| Office Action Summary | Application No. 10/591,188 | Applicant(s) WILLIAMSON ET AL. | |

DETAILED ACTION

1. Determining the scope and contents of the prior art.
 2. Ascertaining the differences between the prior art and the claims at issue.
 3. Resolving the level of ordinary skill in the pertinent art.
 4. Considering objective evidence present in the application indicating obviousness or nonobviousness.
6. Claims 1-11 and 13-19 are rejected under 35 U.S.C. 103(a) as being unpatentable over Marrese et al. (US 4,769,122) in view of Yamada et al. (US 6,410,189).

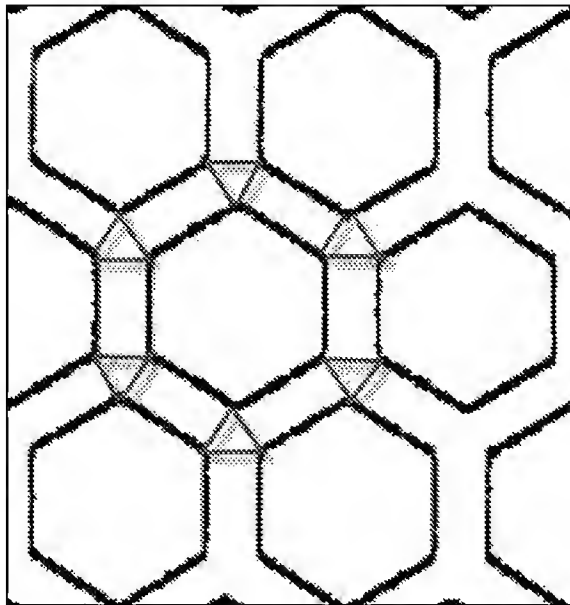
Furthermore, the current collector of Yamada has a thickness of 100 microns or only approximately 0.1mm (5:37-39) and defines a plurality of open areas (figure 5) and the surface area of the portion of the support between the open areas being less than 40% of the combined surface area of the open areas and that portion of the support between them according to the following calculations. The dimension **a** is 0.1 to 5 mm and the dimension **b** is 0.1 to 5 mm, for the calculation, assuming **a** is 4 mm and **b** is 0.1 mm and the area in figure 5 below is used as an example. The area of the hexagon is calculated by equations $((3\sqrt{3})/2)*L^2$ or $(\sqrt{3}/2)*W^2$ (according to

sides of the hexagon. The area of the portion between the hexagons are divided into a plurality of equilateral triangles with each side equals to the dimension **b** and rectangles with the width equals to the dimension **b** and the length equals to the side of the hexagon or half of the dimension **a** according to the source above. Thus, the area for each hexagon is 10.39 mm^2 , the area for each rectangle is 0.2 mm^2 and the area for each triangle is 0.0043 mm^2 . The section of figure 5 below has 7.5 hexagons, 20.5 rectangles and 15 triangles; therefore, the total area of the section of figure 5 below is 82.09 mm^2

and the percentage of surface area of the portion between the hexagons and the total area of the section below is 5.073%.

At the time of the invention, one with ordinary skill in the art would have found it obvious to modify the current collector 58 of Marrese to have the hexagonal openings with the dimensions for the current collector of Yamada or by substituting with the current collector of Yamada because the current collector with the dimensions of Yamada provides electrical connection to the sensing electrode with the openings that allow the diffusion of incoming gas as required by Marrese as well as having low combined resistances and reducing the average current migration lengths within the current collector (Yamada, 2:30-37).
